Product Notification

300/400/600/700 Series Bowl Consolidation

Effective March 2018, all 300, 400, 600 and 700 Series contaminant collection bowl part numbers will be consolidated to two groups, heated and non-heated.

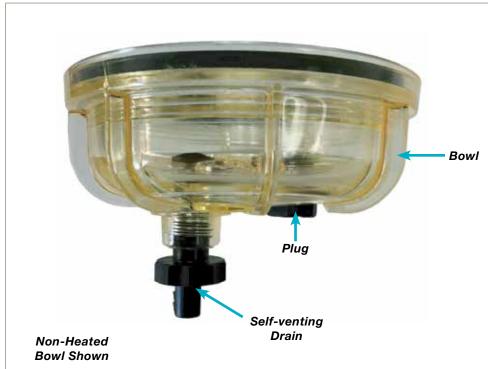
- All bowls will include our selfventing drain knob which does not completely thread-out from the bowl.
- Plug/WIF port threads will be standardized from 9/16"-18 UNF-2B to 1/2"-20 UNF-2B.
- Any bowls that are short-cored (blocked-off, not available for use) and do not have ports for water-in-fuel (WIF) sensors or plugs will be discontinued and replaced by bowls with WIF ports. All bowls will now include either a WIF sensor or a plug in the WIF port.

Current bowls with a short-cored plug/WIF port, "old style" drain, or 9/16"-18 UNF plug are changing, in form only—no change to fit or function, to a new self-venting drain and 1/2"-20 UNF plug. All bowl kit part numbers are changing.
